### Q1 Which of the three bridge designs do you prefer for the Meadow Way Bridge replacement?

## Fairfax Bridge Design

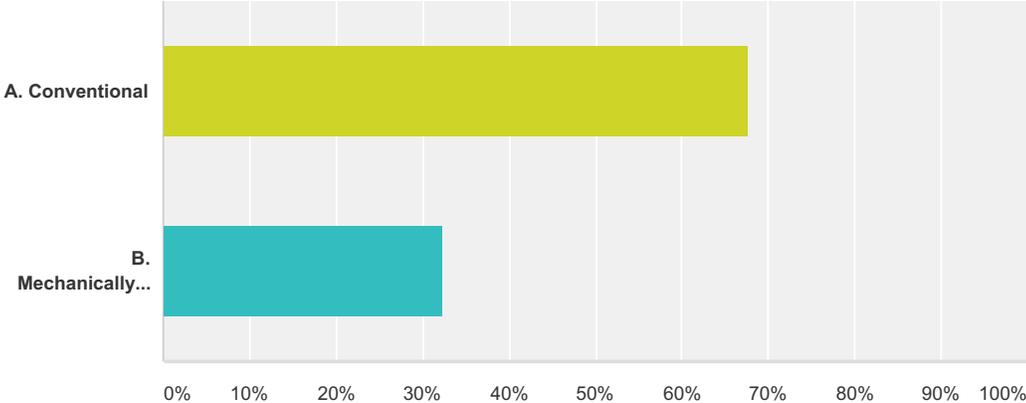
Answer Choices	Responses
A. Concrete Arch Design	61.11% 22
B. Rusting steel Truss Design	22.22% 8
C. Paintedsteel Truss Design	2.78% 1
D. Arch Glulam Wood Design	13.89% 5
<b>Total</b>	<b>36</b>

10	My preference for bridge type is based on the speed of the construction and the lack of impact to my property	7/28/2016 4 25 PM
11	n my preference for a concrete arch bridge vastly prefer that the bridge sides have open "window" between the concrete as shown in the drawing above (as opposed to the SOL D concrete sides shown in the 3 D illustration) probably would prefer that the bridge and retaining wall be constructed of colored concrete in an earthy color The only change to this preference would be to a preference for a steel bridge ONLY if that would make the bridge's completion in one season EXTREMELY likely rather than just a remote possibility and even then it would depend on a clearer sense of the hours of construction (even assuming work would proceed for 7 days a week)	7/28/2016 3 51 PM
12	Need pedestrian access from meadow way bank to creek bed for general access and fire egress in emergency	7/28/2016 3 14 PM

13	The north side of the new bridge should align with the north side of the existing bridge Moving the bridge 7' to the south is not acceptable	7/28/2016 2 58 PM
14	[REDACTED] Can the north alignment of the road stay the same? t looks like the bridge will be moved to the south	7/28/2016 11 27 AM
15	[REDACTED] STRONGLY prefer no lights on the bridge need to understand better the different kinds of retaining walls in order to state a preference but think the 2 homes adjacent to the walls should have the loudest vote	7/27/2016 9 50 PM
16	Thanks for all the detail and ability to provide input [REDACTED]	7/24/2016 9 29 PM
17	Steel drop in bridge to expedite process 1year process natural creek access least amount of concrete as possible cal trans has just approved 10 foot lanes on the El Camino Real down the Peninsula why do we need 12 foot lane??	7/24/2016 12 44 PM
18	Could a concrete bridge have wood railings or could concrete railings be covered with wood?	7/22/2016 7 31 PM

### Q3 Which of the above Erosion Control Wall finishes do you prefer for the Meadow Way Bridge?

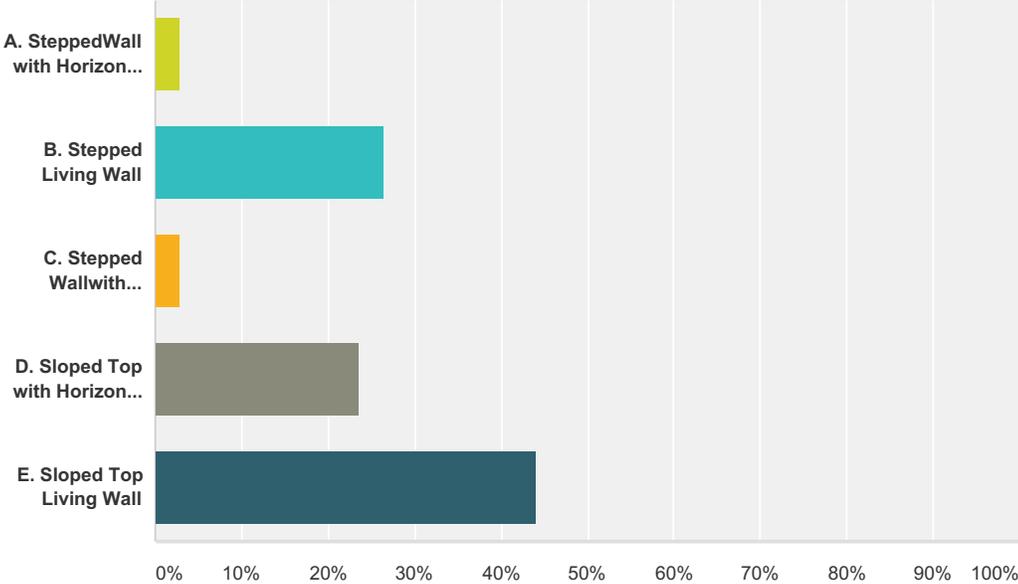
Answer Choices	Responses
A. SteppedWall with Horizontal Grooves	2.94% 1
B. Stepped Living Wall	26.47% 9
C. Stepped Wallwith Two-Way Grooves	2.94% 1
D. Sloped Top with Horizontal Grooves	23.53% 8
E. Sloped Top Living Wall	44.12% 15
<b>Total</b>	<b>34</b>

20	NO lights above rails Must have creek access regardless of type of retaining walls for wild life neighbors and as emergency exit if Cascade Drive is closed	7/21/2016 4 49 PM
21	What effect will the different wall texture treatments have on flow turbidity flow speed and maintenance of the channel? Will the pretty "living wall" result in maintenance issues and reductions in flow or capacity similar to issues caused by ivy growing at the Morningside neighborhood bridges?	7/21/2016 4 40 PM
22	voted for the conventional wall construction mostly because believe the MSE approach cannot be done in the area next the to the bridge due to excavation requirements without closing the road for an extended period	7/21/2016 3 36 PM
23	Please ensure that local sources of native plants are incorporated local to the watershed	7/21/2016 3 23 PM
